Central Valley Regional Water Quality Control Board

NOTICE OF VIOLATION

**INSPECTION REPORT – VALLEY WATER MANAGEMENT COMPANY, C-PLANT FACILITY,
EDISON OIL FIELD, KERN COUNTY**

FACILITIES INSPECTION REPORT

FIGURE 1

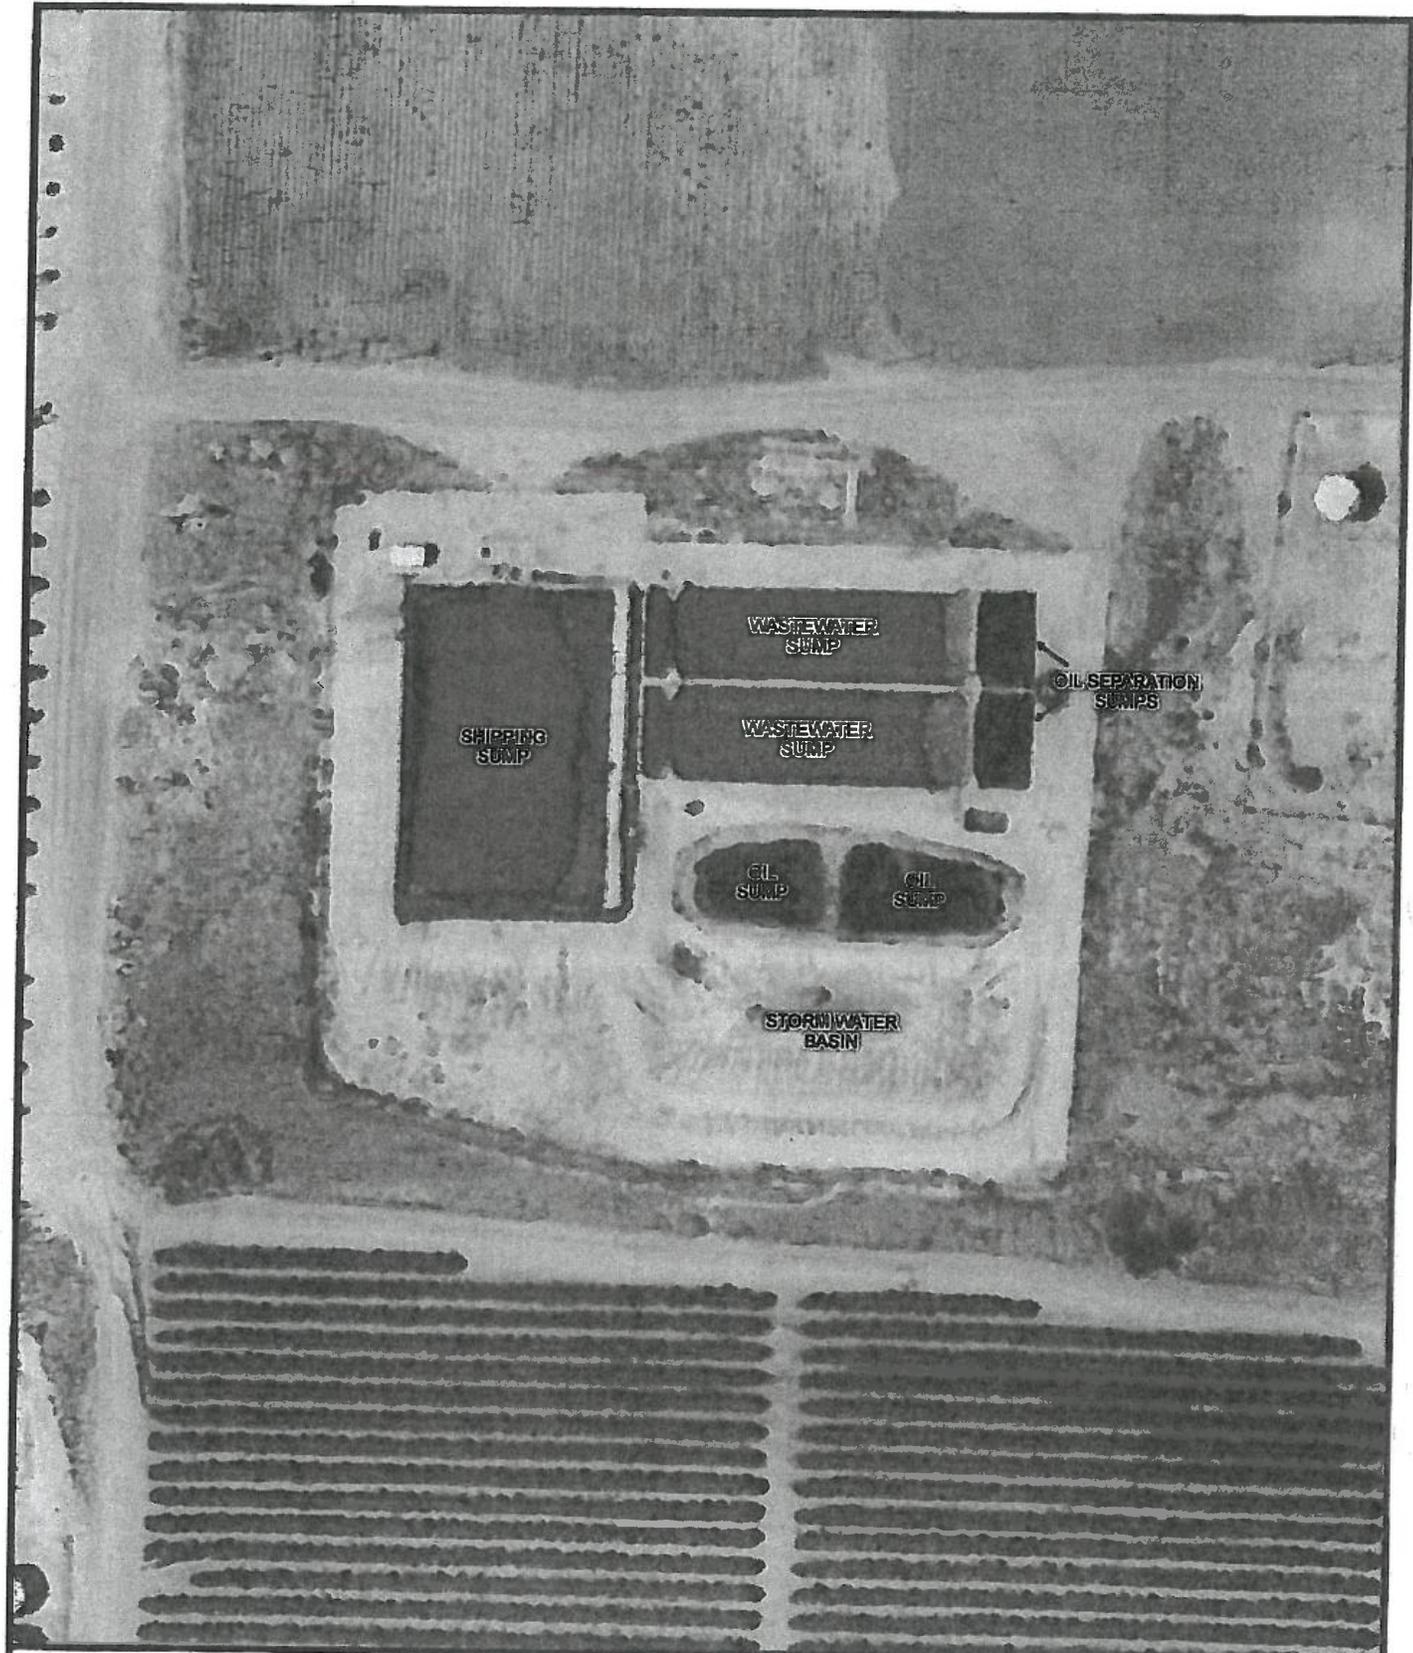
Staff observed that oil field produced wastewater was being discharged into seven surface impoundments (sumps) at the facility. Two sumps (referred to as wastewater sumps; see Figure 1) appeared to have insufficient freeboard (approximately 1 foot of freeboard) and are in violation of the WDRs. Waste Discharge Specification B.6 of the WDRs states that a minimum of two feet of freeboard needs to be maintained in the sumps. The final sump in the series has recently been covered with netting to preclude wildlife.

2. The two wastewater sumps appeared to have insufficient freeboard (approximately 1 foot) and are in violation of the WDRs. Waste Discharge Specification B.6 of the WDRs states that a minimum of two feet of freeboard needs to be maintained in the sumps.
